Rawlson King

Councillor / Conseiller, Rideau-Rockcliffe

Policy Position on Manor Park Official Plan Amendment

The current view from the backyard of 8 Jeffrey Street. Neighbours along Jeffrey don't want the building any closer to their yards then they already are to maintain light, tree canopy and privacy.

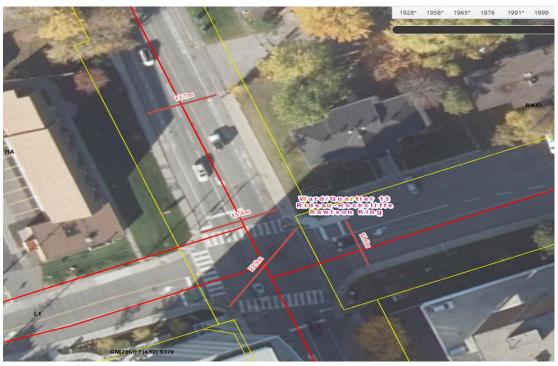
I heard very clearly from the residents and neighbours of Jeffrey Street that with their gardens immediately abutting the proposal for Block 1, they would prefer a reorientation of the stacked townhomes. In their discussion with myself, they also noted that they would like to see amenities be placed behind with the homes facing Eastbourne and personally, I also believe that having the homes be ground facing also leads to a better walking experience through the neighbourhood. It allows for front porches, which encourages more personal interaction and streetscape animation. Since the residents of Jeffrey Street expressed concerns about shadowing affects, the developer should entertain a reorientation of those buildings in order to mitigate shadowing effect on their rear yards.
